APPLICATION NO.	FILING DATE	FIRST NAMED INVENTOR	ATTORNEY DOCKET NO.	CONFIRMATION NO.
09/917,749	07/31/2001	Yasutaka Ito	110575.01	2777

Office Action Summary

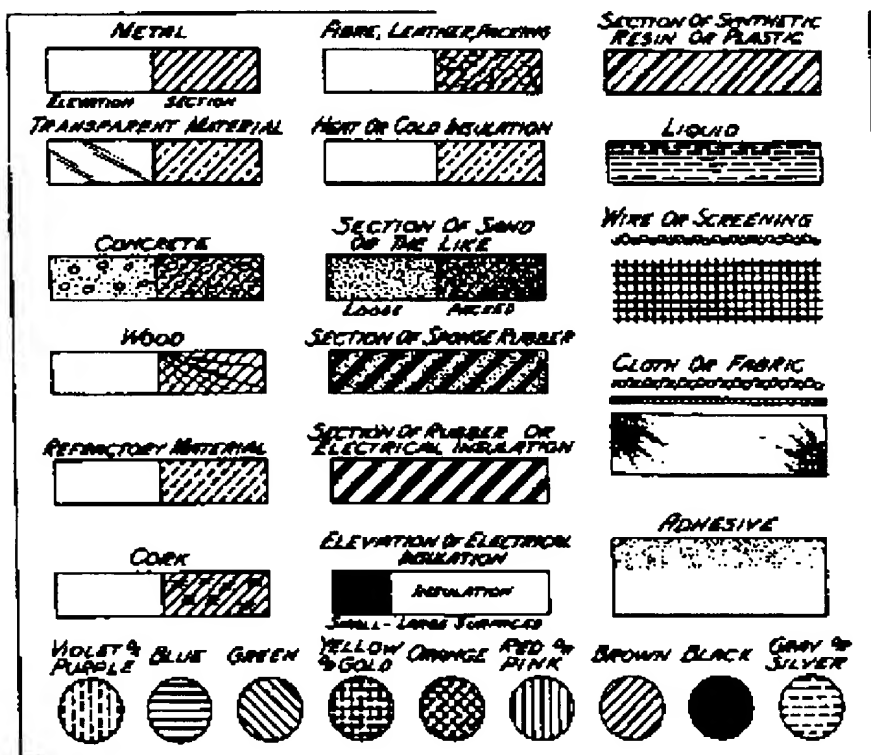
Figs. 1-3, 5, 7-11, 13: Proper cross-sectional hatching is required to properly denote insulative materials in accordance with MPEP 608.02 (see the drawing below for proper hatching examples).
